AGENDA
PLANNING COMMISSION PUBLIC HEARING/REGULAR MEETING
CITY OF FARMINGTON HILLS
AUGUST 20, 2026 at 7:30 P.M.
FARMINGTON HILLS CITY HALL – CITY COUNCIL CHAMBER
31555 W. ELEVEN MILE ROAD, FARMINGTON HILLS, MICHIGAN 48336
Cable TV: Spectrum – Channel 203; AT&T – Channel 99
YouTube Channel: <https://www.youtube.com/user/FHChannel8>
www.fhgov.com (248) 871-2540

A. SPECIAL APPROVAL SITE PLAN 56-7-2026

LOCATION:	29375 W. 10 Mile Road
PARCEL I.D.:	22-23-25-101-018
PROPOSAL:	Construct a new specialty veterinary clinic within the B-3, General Business District
ACTION REQUESTED:	Planning Commission Public Hearing (Special Approval Use)
APPLICANT:	Katharine Podsiad
OWNER:	Bhachandra Sata

Special Approval Use & Site Plan Review for The City of Farmington Hills

SP-1

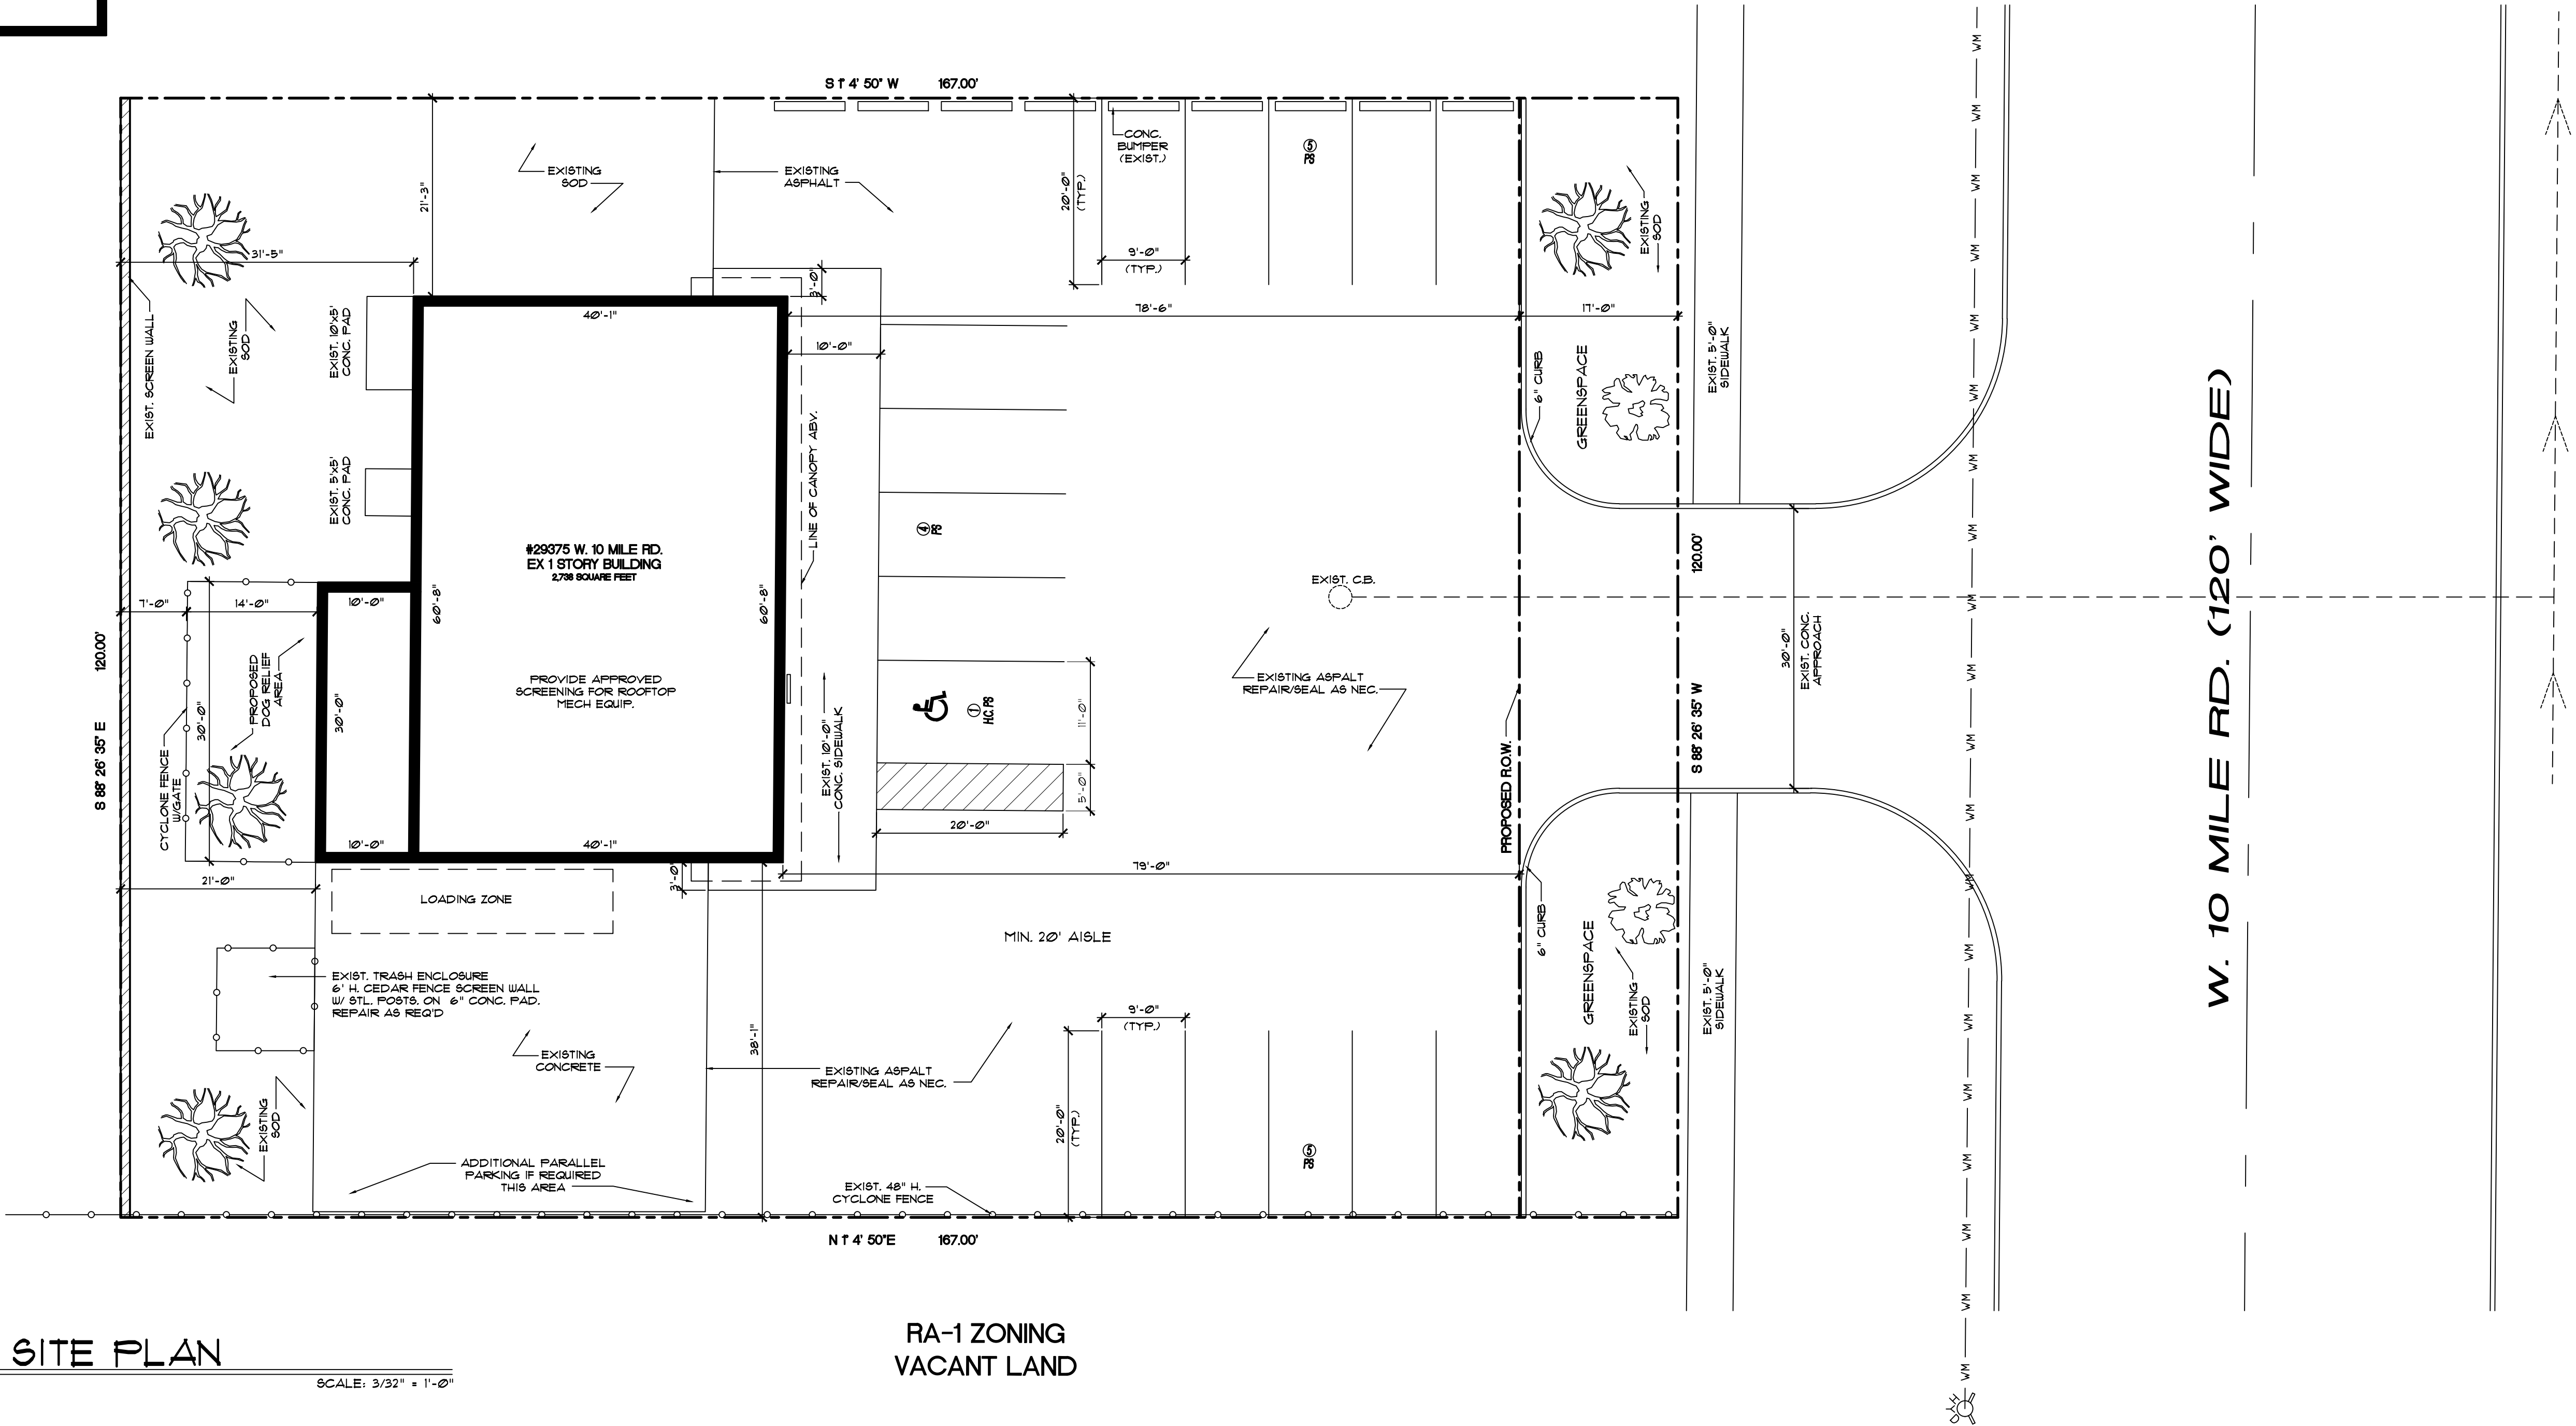
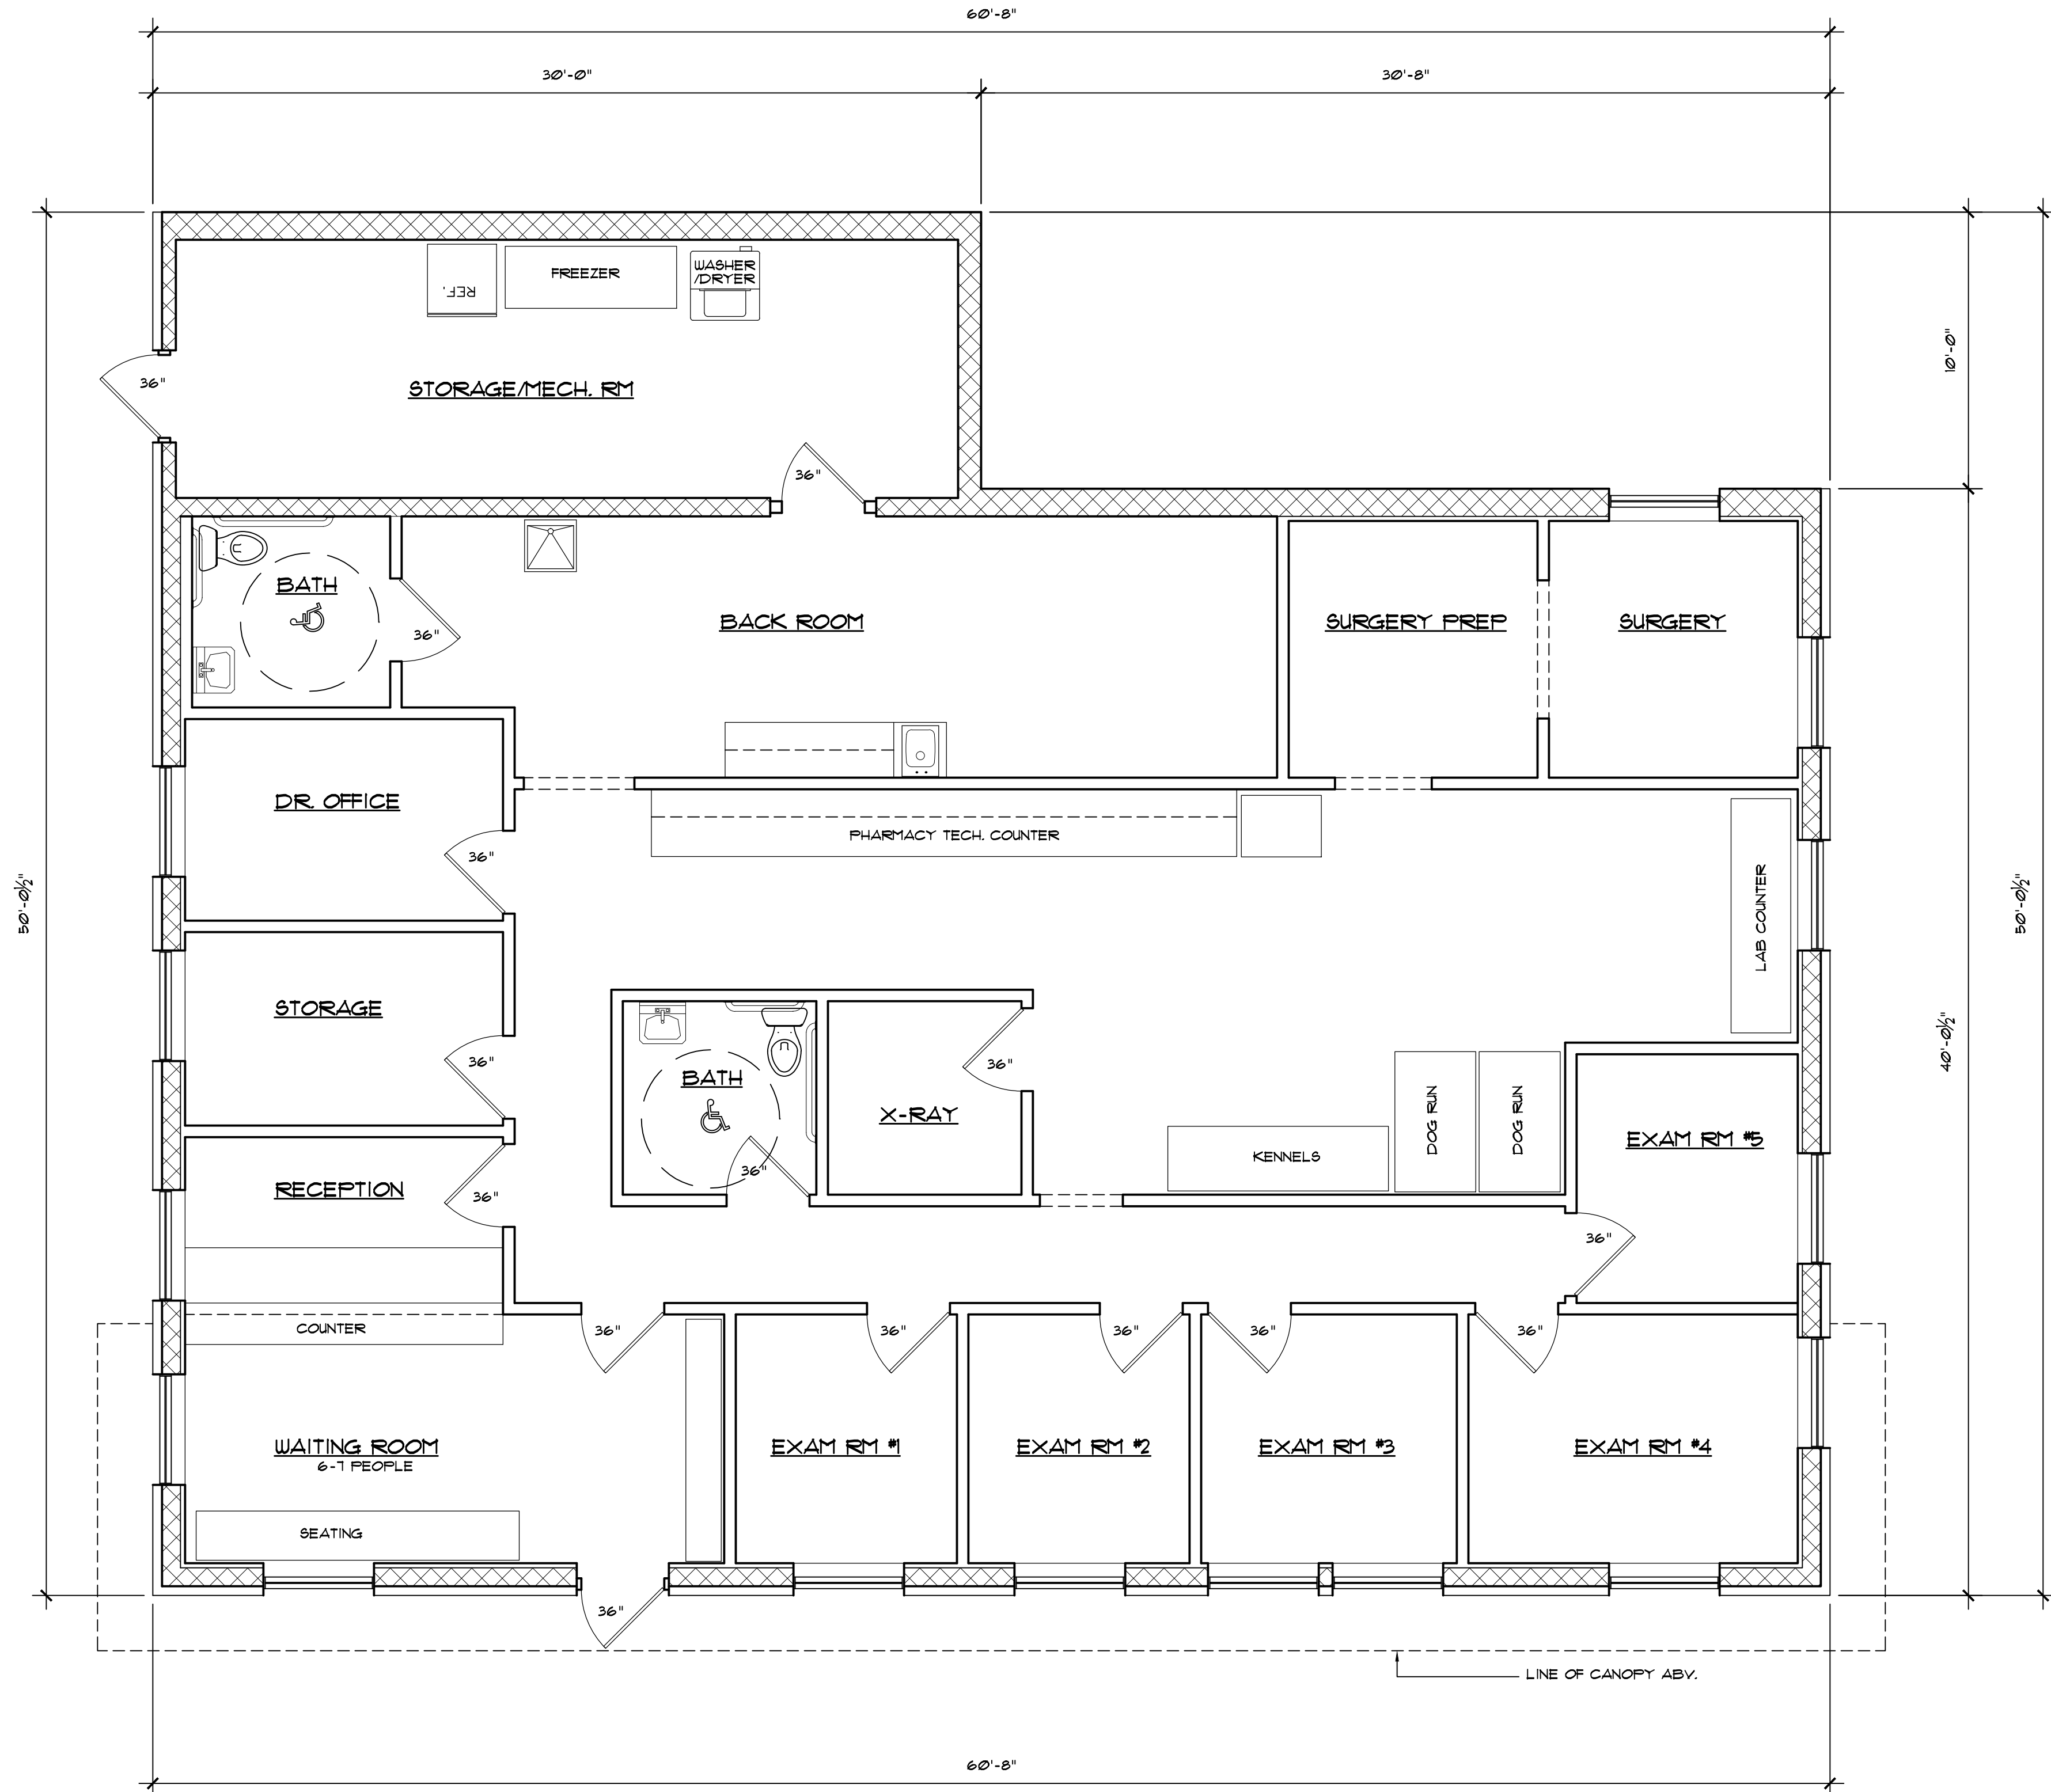
¹ Setback dimensions based on topographic survey. Site plan dimensions needs to be corrected.

The applicant must include the legal description and parcel identification number on the site plan. Setback dimensions shown on the site plan need to be corrected to match those shown on the topographic survey. Front setbacks are to be measured from the proposed future right-of-way. The Site Data table shown on Sheet SP-1 must be corrected to reflect the B-3 District development standards (Section 34-3.1.25.E) as well as all existing and proposed dimensions.

- 1) *The applicant must include the legal description and parcel identification number on the site plan.*

- 2) *Setback dimensions shown on the site plan need to be corrected to match those shown on the topographic survey. Front setbacks are to be measured from the proposed future right-of-way.*

- 3) *The Site Data table shown on Sheet SP-1 must be corrected to reflect the B-3 District development standards (Section 34-3.1.25.E) as well as all existing and proposed dimensions.*

- 5) *The applicant must submit building and mechanical plans that confirm the building will have central air conditioning.*
- 6) *The dumpster enclosure location must be specified on the plan.*

- 7) *Dumpster enclosure details must be provided.*
- 8) *The applicant must correct the parking space requirement listed on the plan.*
- 9) *The applicant must confirm the number of existing and proposed trees.*

- 10) *Required canopy (deciduous) plantings must be provided.*
- 11) *The curbed area separating the parking lot from the front lot line must be planted with a hedge of small shrubs as defined in subsection 34-5.14.3.F.v., or by a masonry wall or berm a minimum of two (2) feet high.*
